August 2018
FL752A-D
NHTSA #17V-665
Transport Canada #17-513

Subject: FCCC Bus Chassis Fuel Line Interference

Models Affected: Specific Freightliner Custom Chassis B2 school bus chassis (Thomas Built Buses Saf-T-Liner C2) manufactured August 23, 2011, through September 29, 2017.

Fig. 19, Replacing Bracket 06-09782-000, Dual Height Control Valve

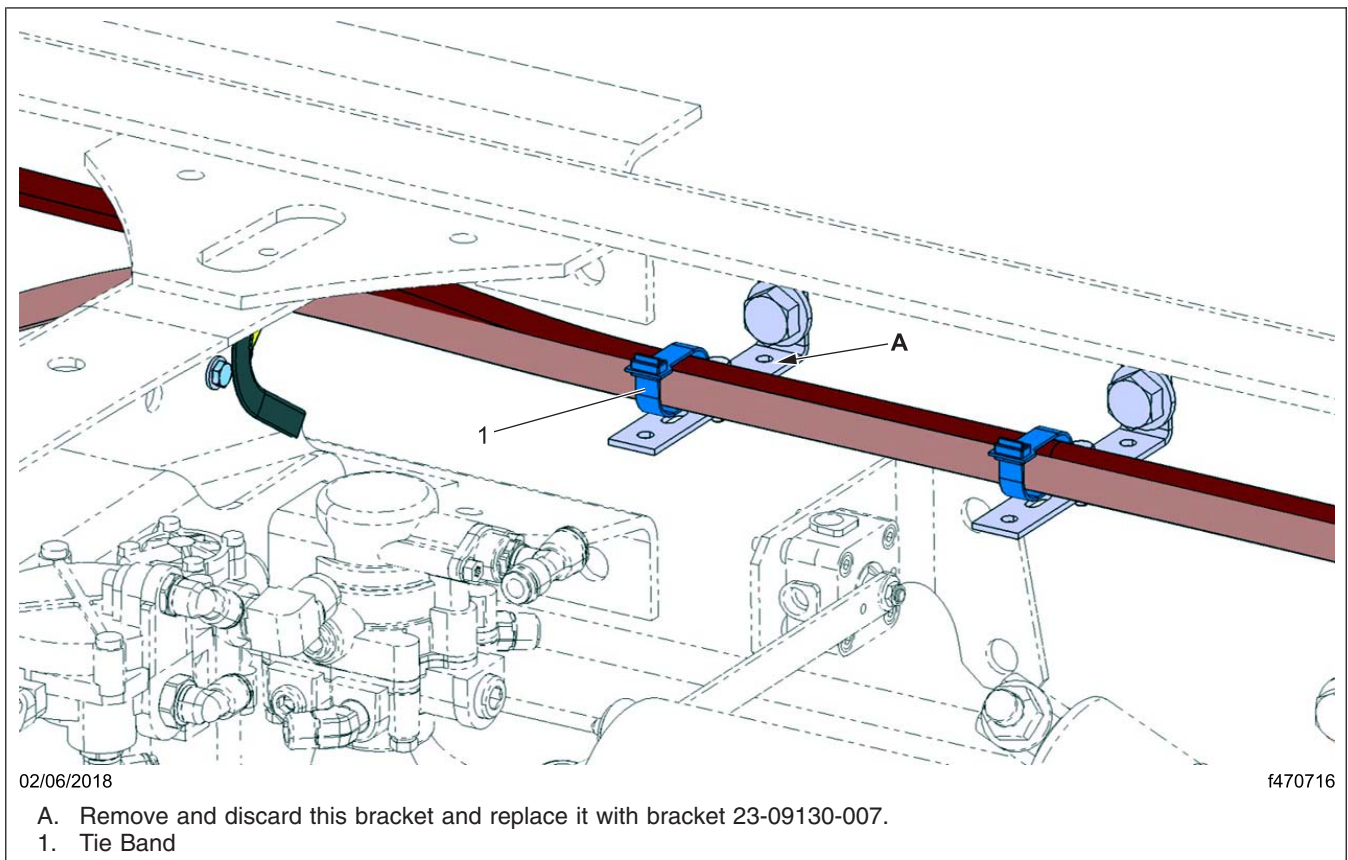
1. Remove the tie band around the fuel lines. See [Fig. 19](#), Item 1.
2. Remove and discard the indicated bracket and install new bracket 23-09130-007. See [Fig. 19](#), Ref. A, for the location of the bracket.
